MARK™ VIE NETWORK SWITCHES

GEA35433 (02/2024)

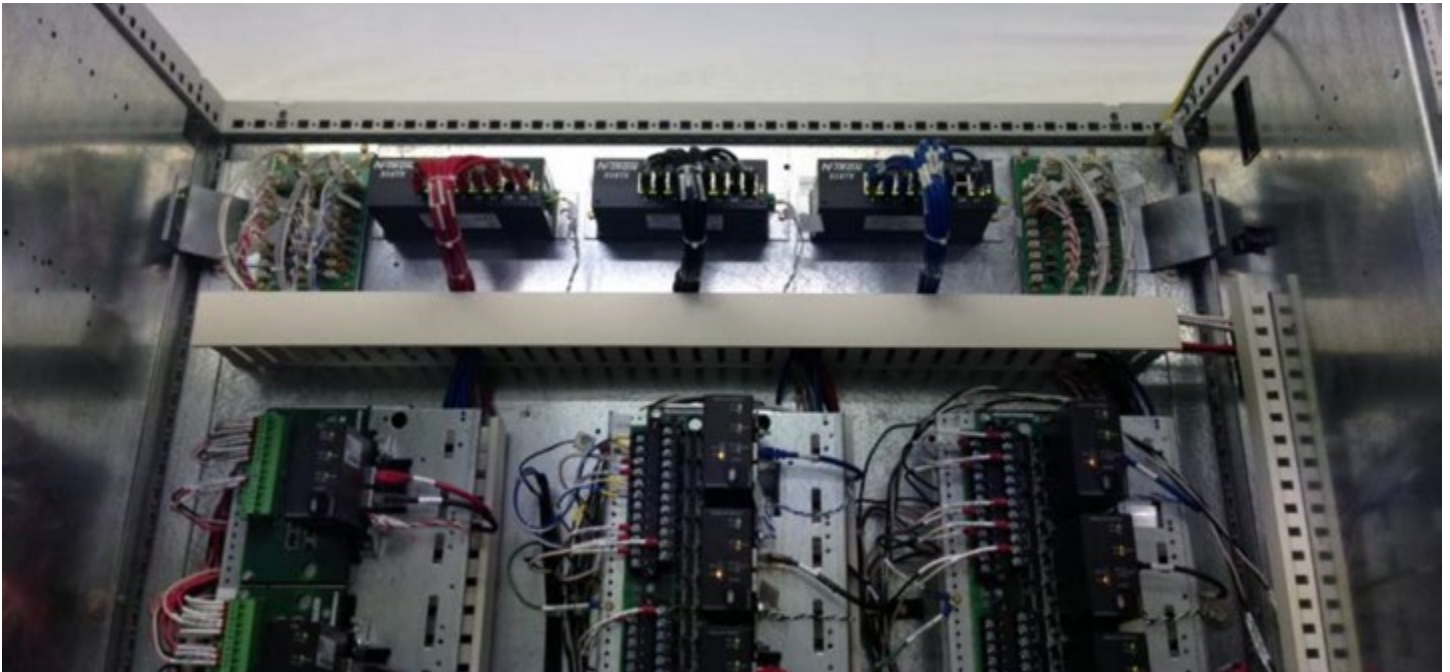
GE Vernova has engineered and developed an alternative IONET ethernet switch shown below, which is backward compatible with the existing N-TRON switches and may be mixed with the N-TRON switches in an existing Mark VIe or Mark Ve control system. In most cases, once new switches are received, they are easily mountable in an existing panel. However, in some applications an additional fiber connector kit may be required. GEI-100810 should be referenced for specific guidance with mounting these new switches.
